REQUEST

Current Zoning: O-1(CD) (office, conditional)
Proposed Zoning: O-1(CD)SPA (office, conditional, site plan amendment)

Approximately 1.27 acres located on the north side of Ballantyne Commons Parkway, east of Rea Road (Council District 7 - Driggs)

SUMMARY OF PETITION

• **Proposed Request Details**

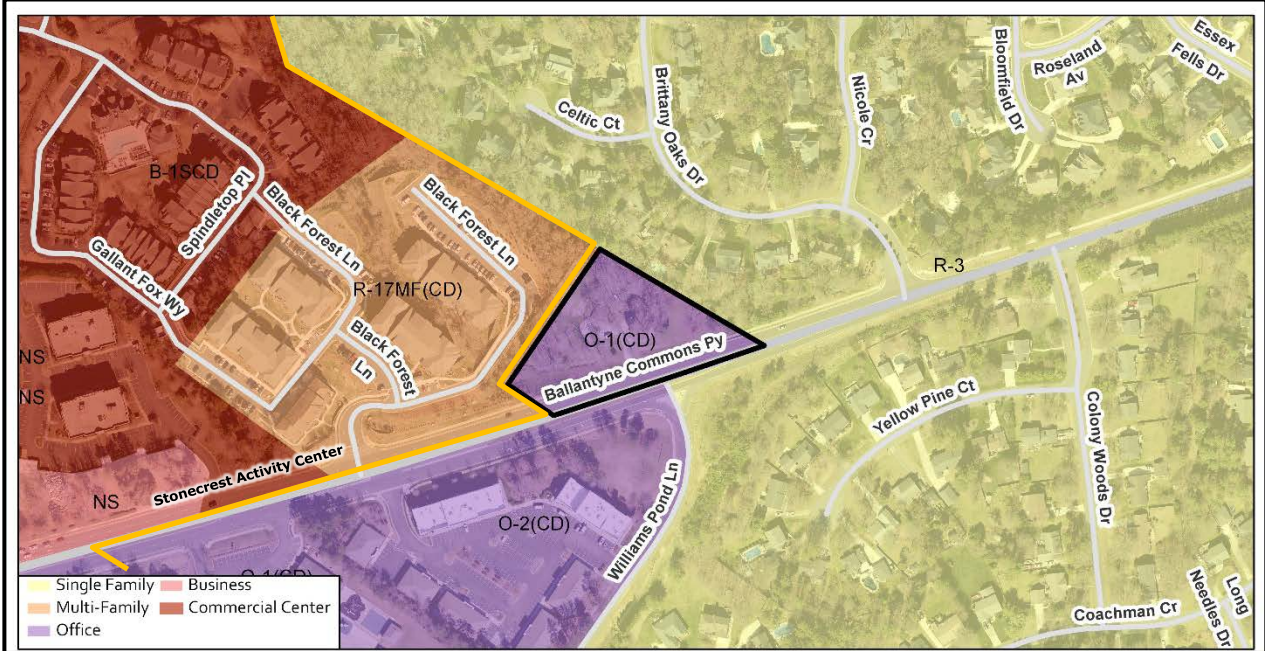
1. Expand Note 7 under Architectural Guidelines to state that the entry plaza will include pedestrian amenities such as, but not limited to, seating areas, art, water features and/or specialty landscaping.

2. Label the storefront entry and clear glass windows on the first floor of the building renderings.
3. Amend the buffer and label along the northwest property line to provide a 12-ft wide (16 feet reduced by 25% with the screening fence) Class C buffer, rather than 10 feet as shown on the site plan. In addition, add a note under Streetscape and Landscaping that reads "A 16' Class C buffer along the northwestern property line will be reduced to 12-ft with the provision of a 6' tall screen wall."

4. Amend the site plan to show a 16-foot Class C buffer along the northeastern property line rather than a 15-foot buffer. In addition, amend Note 12 to read "The 16' Class C buffer may not be reduced along the northeastern property line. A 6' tall screen wall will be provided along the northeastern property line."

5. Add a note under Streetscape and Landscaping that states "Petitioner agrees to provide an eight-foot planting strip behind the future back-of-curb along Ballantyne Commons Parkway."

6. Update the site plan to show two feet of right-of-way behind the sidewalk or show a two-foot easement behind sidewalk.

7. Add note that site must comply with the Tree Ordinance.

8. Amend Note 6 under architectural guidelines to correct the spelling of Ballantyne Commons Parkway, amend Note 17 under Transportation to correct the spelling of crossover, and change the word "designated" to "designed" in Note 18 under Transportation.
9. Indicate the distance the future curb is from the centerline of Ballantyne Commons Parkway.
10. Amend Note 10 under Streetscape and Landscaping to change the setback from 20 feet to 30 feet as shown on the site plan.
11. Change the label for "large maturing trees" to "required street trees."
12. Delete the last sentence of Note 10 under Streetscape and Landscaping because street trees are regulated by the Tree Ordinance.
